Attachment K
Revision of Tree Impact Report
(With Prior Arborist reports dated
8/16/2008 and 10/27/2007)
(LIB120101, LIB120142,
LIB080510, LIB080105)

PLN060603

Supplement to Report of Certified Arborist

Jeff Taylor Property
 Carmel Valley, CA
 Rancho El Potrero
 A Proposed Subdivision

TREE IMPACT EXHIBIT

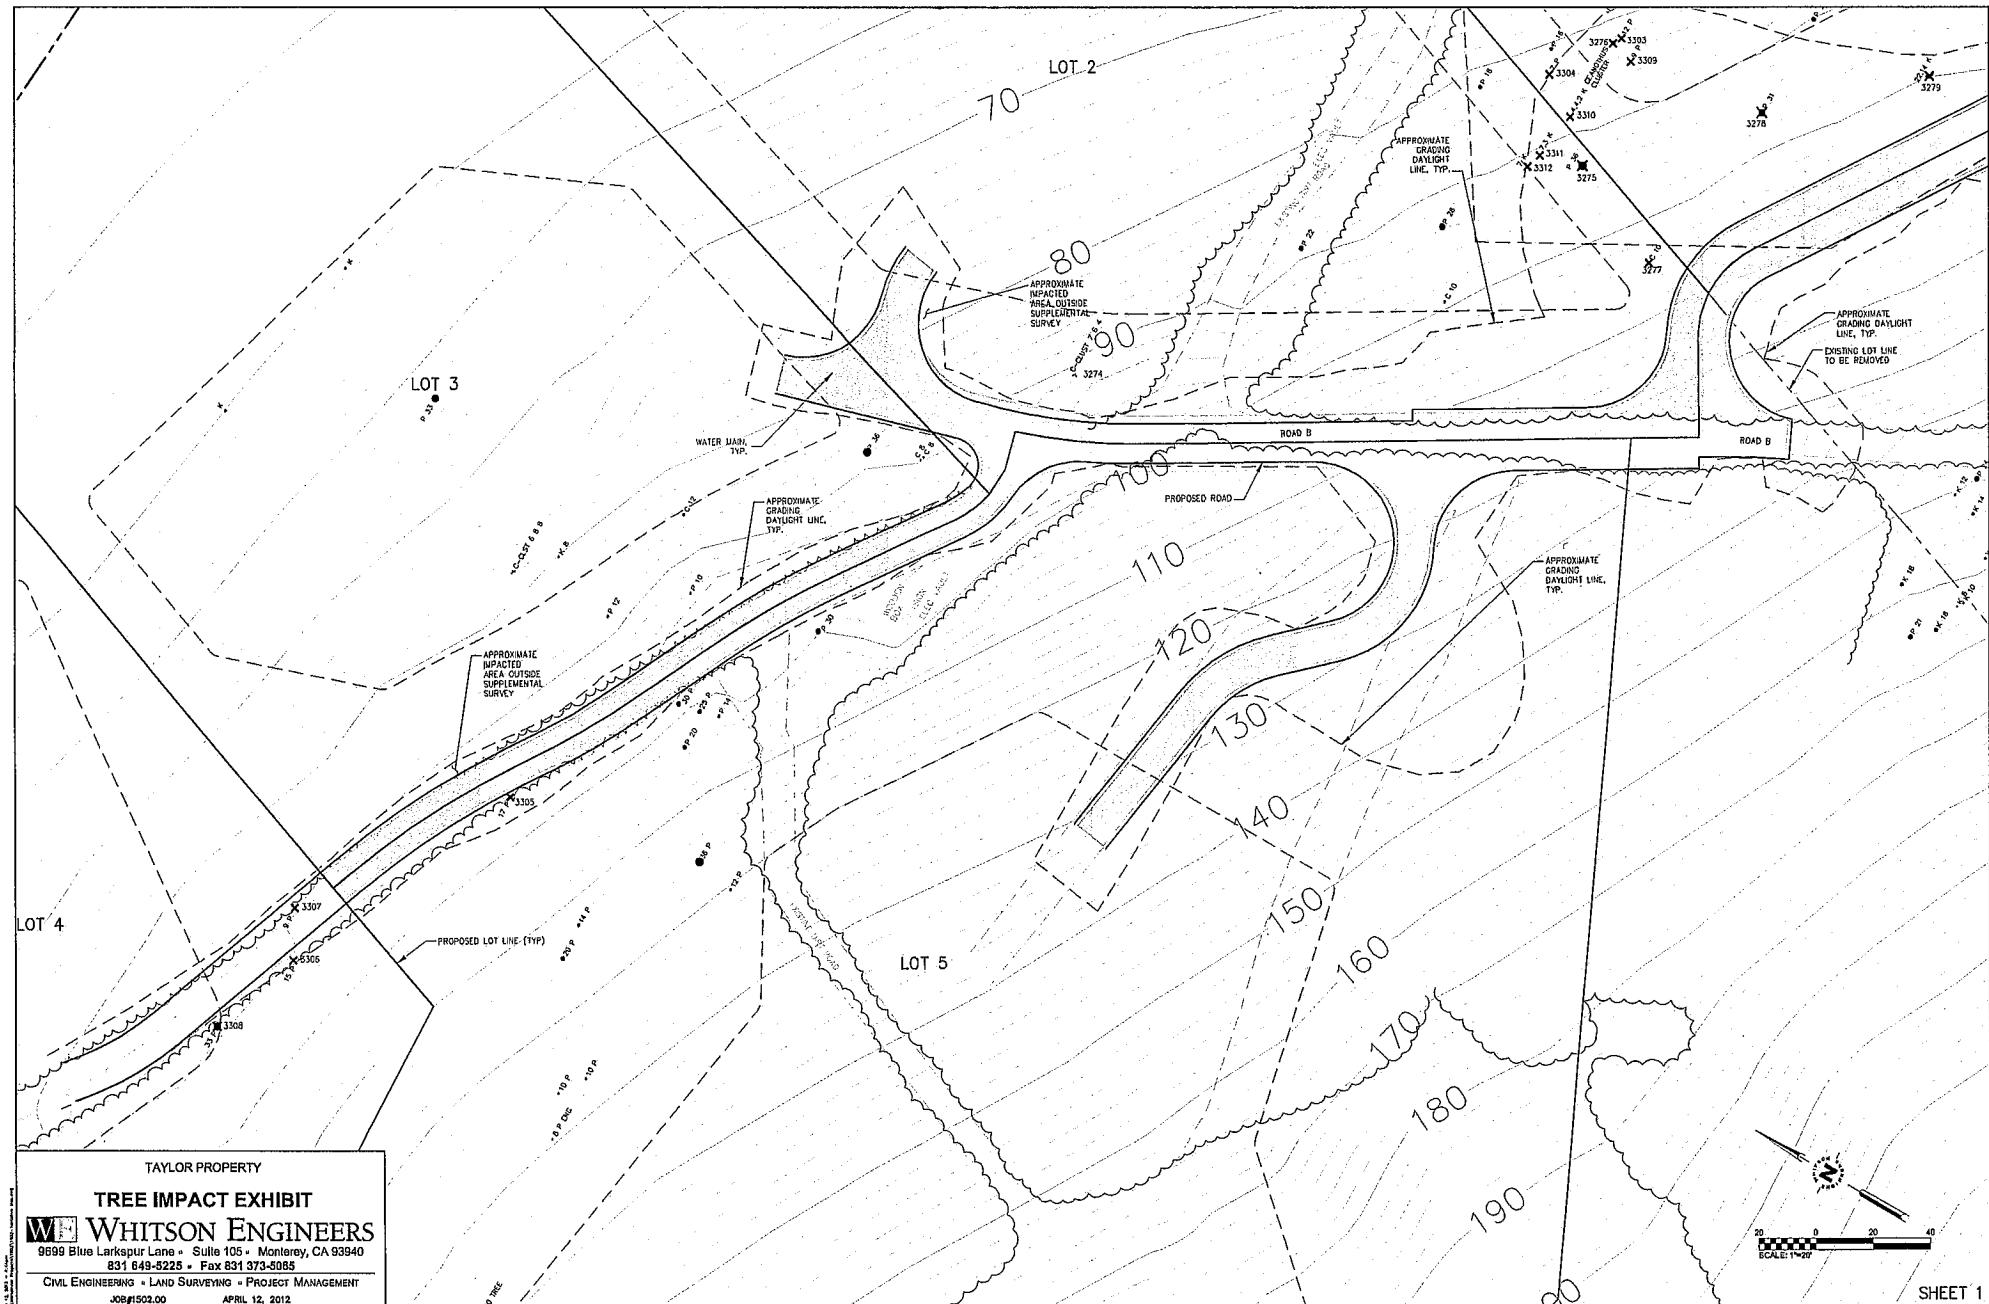
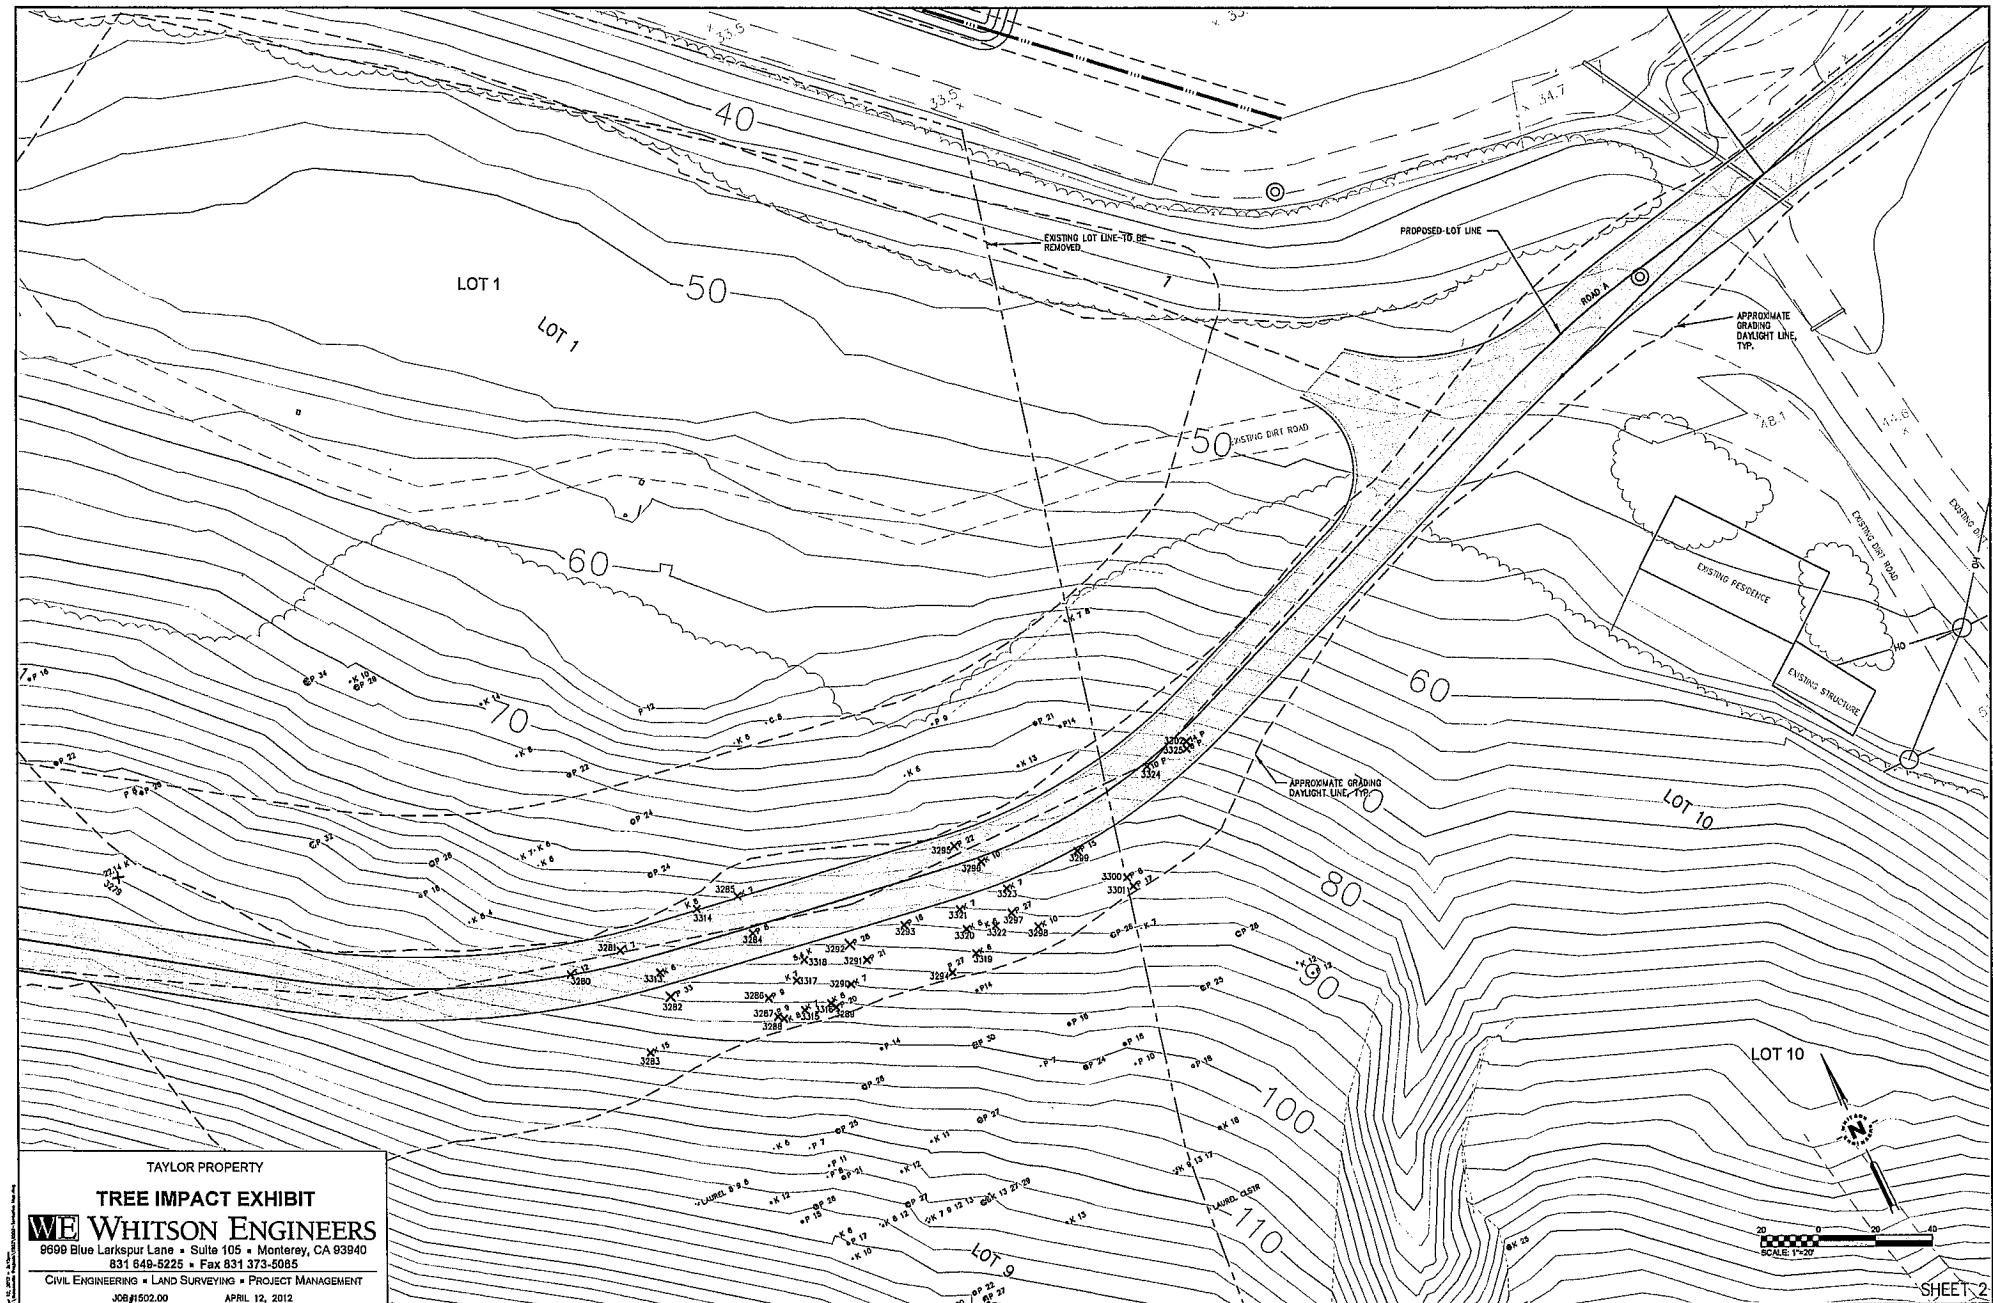
Here I will address the Planning Department letter of June 9, 2011 from Paula Bradley, Associate Planner, to Jeff Taylor, which requested additional information preparatory to the Department beginning work on the Initial Study for this project.

In sum, the letter requests under the heading Tree Removal, the following:

- a) that the arborist's Tree Inventory Table for Removals show the condition of the listed trees ; that tree diameters be measured two feet above ground; that all the protected oaks proposed for removal be identified.
- b) that the Whitson Engineers Tree Impact Exhibit indicate each tree proposed for removal with an X; that the tree removal totals on the Whitson Tree Impact Exhibit and the Arborist's Tree Inventory Table for Removals correspond; that the indicated species of trees on the Exhibit and the Inventory Table correspond and be correct.

Both the Exhibit and the Inventory Table have been revised and corrected and now meet all the requirements stated above. Both are attached.
